**SUPPLEMENTAL INFORMATION
ADDENDUM NO. 3**

PROJECT: ITB No. 19-008 - Fort Howard & Old Augusta Road Roundabout

DATE ISSUED: July 3, 2019

TYPICAL SECTION #3

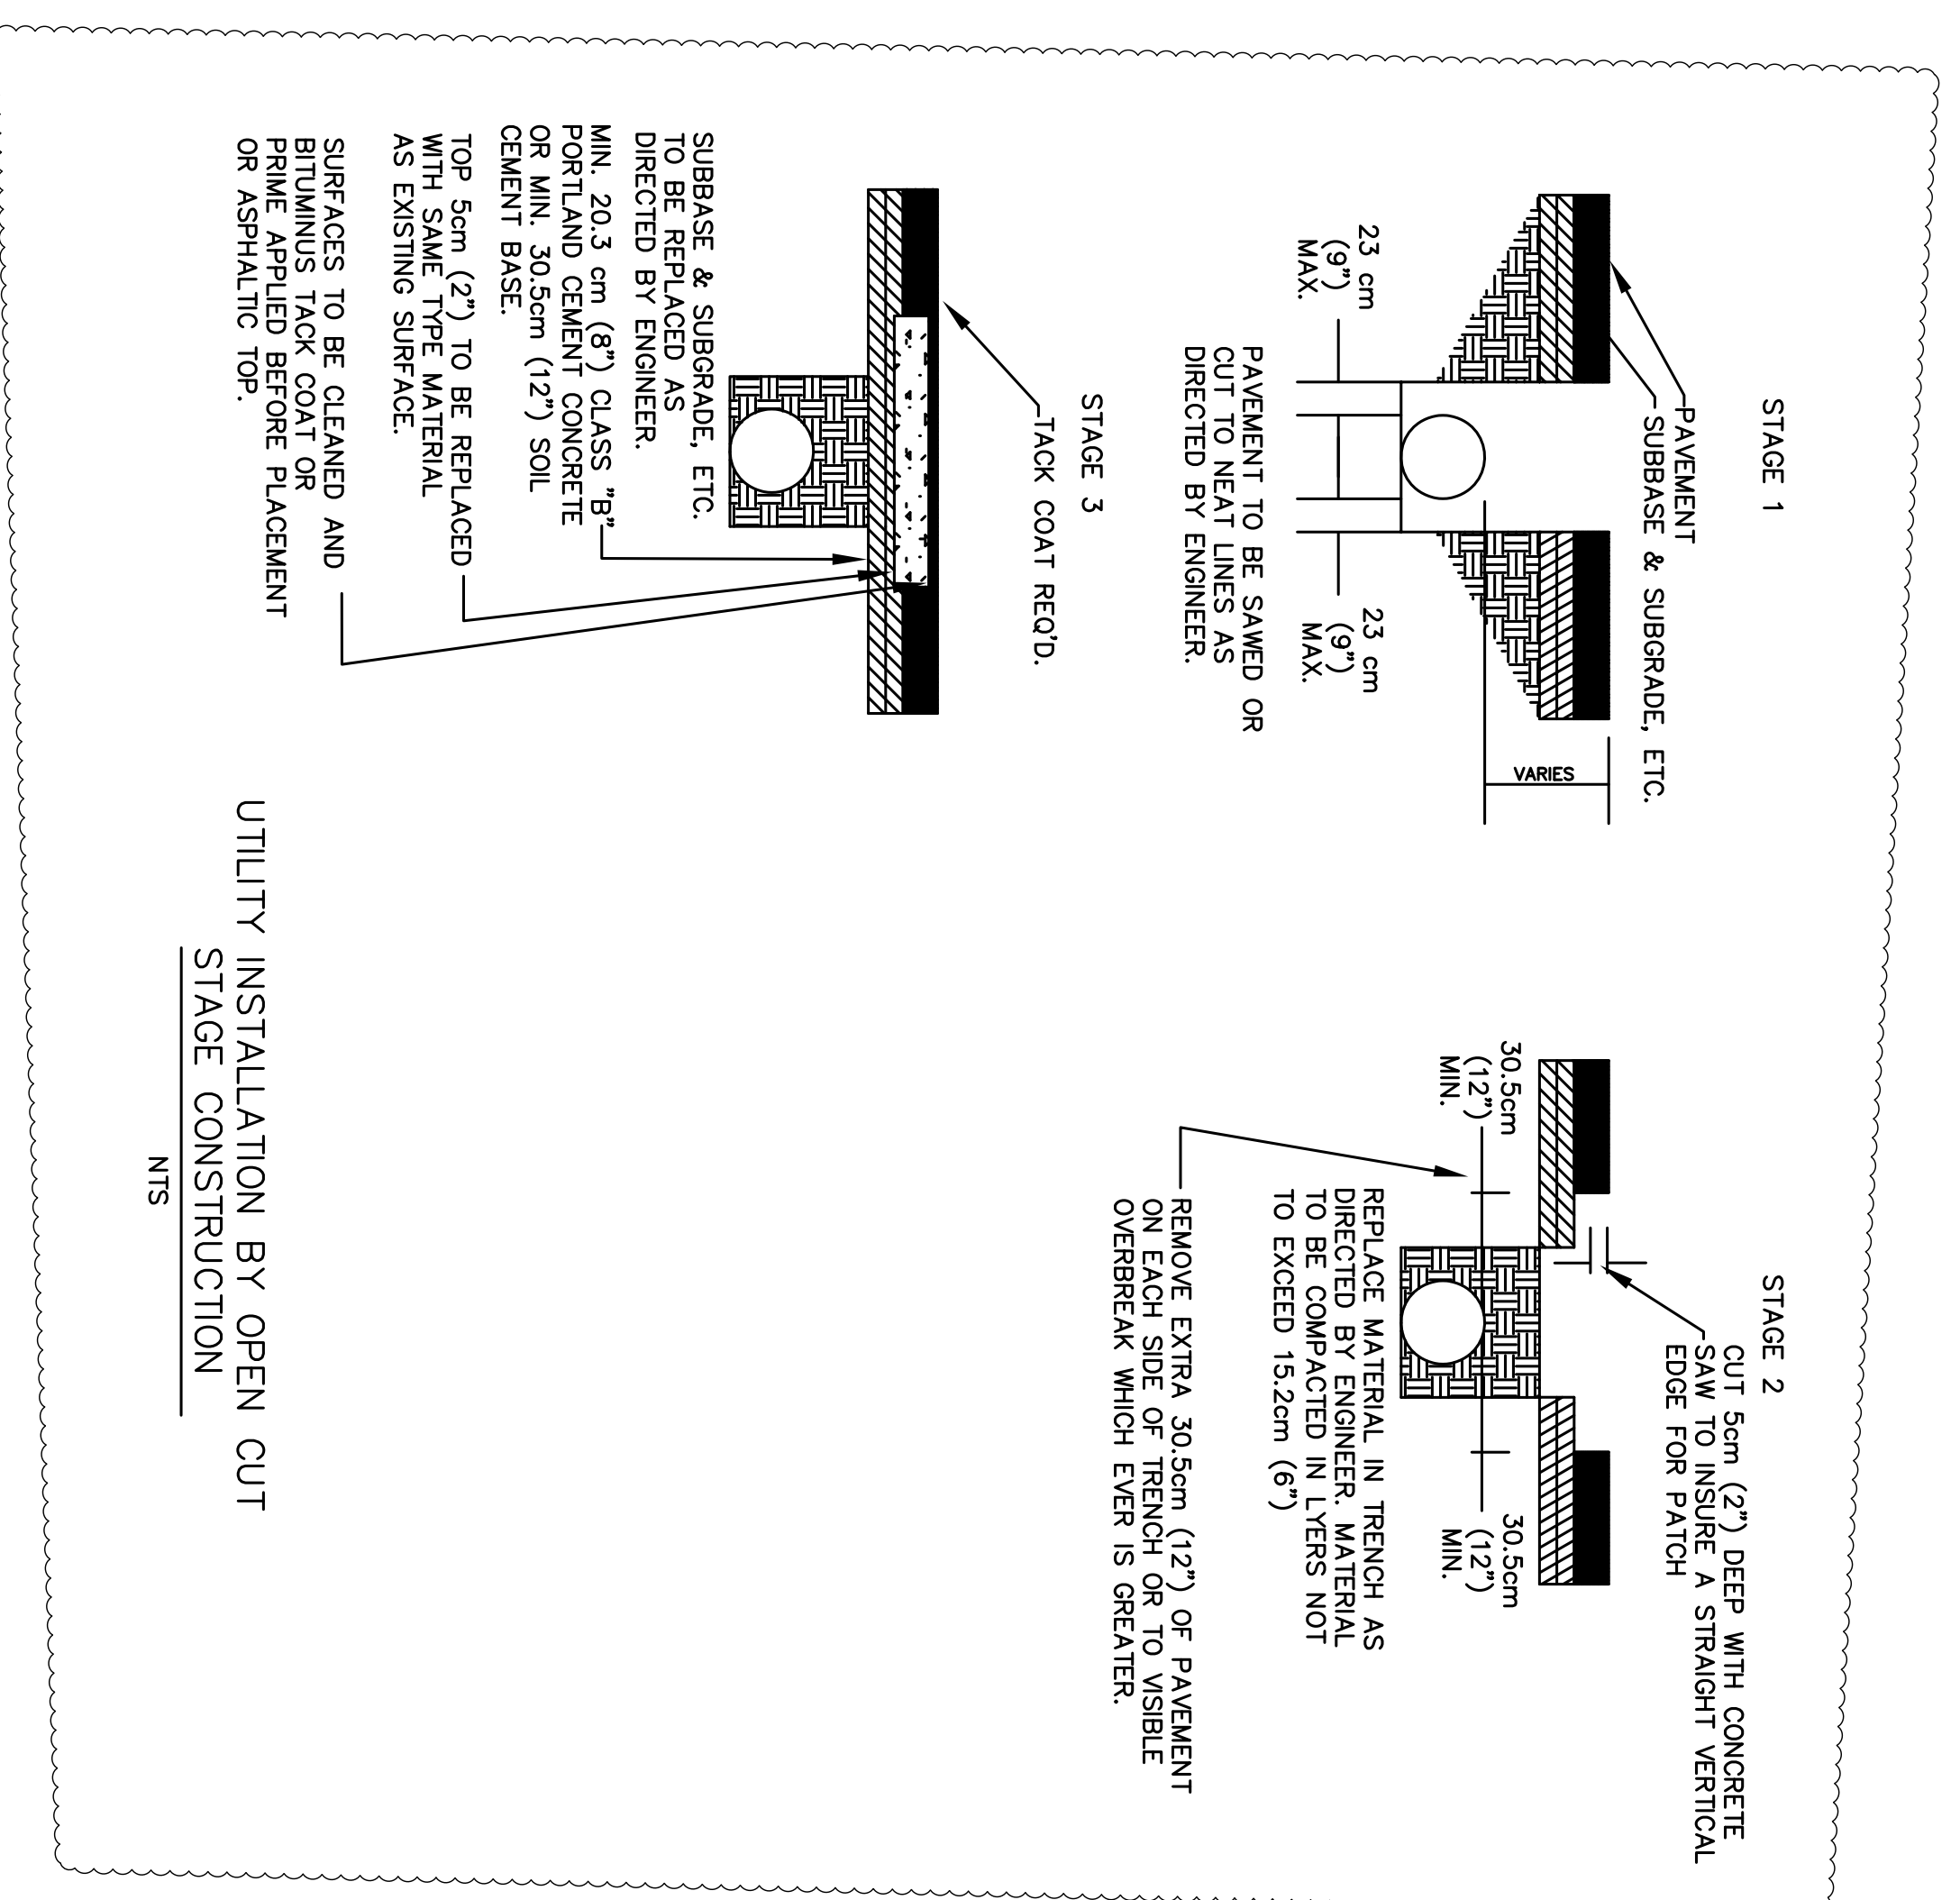
- 2) **QUESTION:** In the plans general note number 2 states that drives shall be constructed with 165 lb/sy of 12.5mm asphalt. The summary of quantities page shows 60 tons of 19.0mm to be placed on drives.
- a. Would the county please clarify if the drives will only require 12.5mm asphalt over GAB or both 12.5mm and 19.0mm asphalt over GAB?
 - b. If the 19.0mm is not required on the drives, would the county please adjust the 19.0mm asphalt to reflect this deduct?

- 3) **QUESTION:** In the plans all three typical sections for this project do not reference placing any 25.0mm asphalt (D, E). The summary of quantities page shows 630 tons of 25.0mm to be placed on the project. Would the county please clarify if the typical sections are correct in stating that no 25.0mm is required, however if this mix is required would the county please revise the typicals to reflect as such?

- a. See note on sheet 5-01. Only 12.5 MM superpave (1.5") is required for drives only to be overlain. Full depth pavement drives shall mirror cross section thickness for typical section #1.
- b. See item 2a.

ANSWER: For typical sections 2 and 3, the bottom asphalt layer letter should be "D" (25 MM asphalt), not "C" (more 19 MM asphalt). Typical section can be found at the end of the Addendum.
